Access Compliance Report

Public Rights-of-Way

(Island Curb Cuts)

| Intersection ID: 23966 | Main Street: CAROLINA PAVILION DR_N | Cross Street: SOUTH BV | Location: SW |

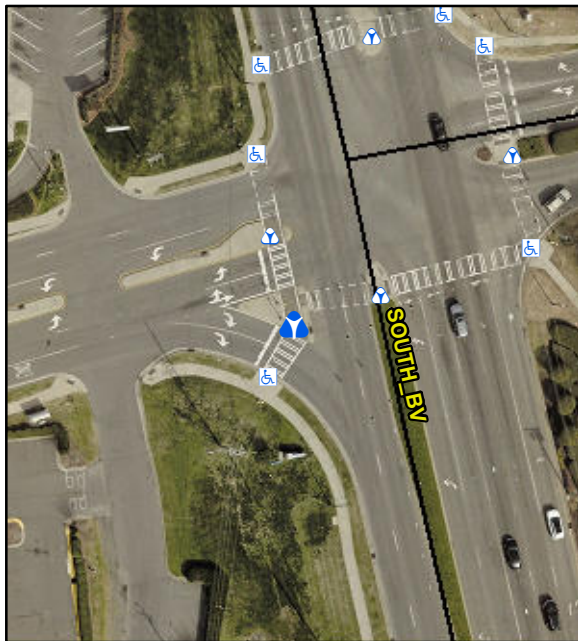
| ADA ID: 362CA56AB464 | Curb Cut Type: IslandRefuge3 | Initial Pass/Fail: Fail | Overall Compliance: No |

| Compliance | Description | Data | Compliance | Description | Data |
|------------|----------------------|-------|------------|-----------------------------|------|
| No | Refuge 3 Slope (%) | 5.6 | N/A | Gutter 3 Slope (%) | N/A |

Remove & Replace Entire Refuge.
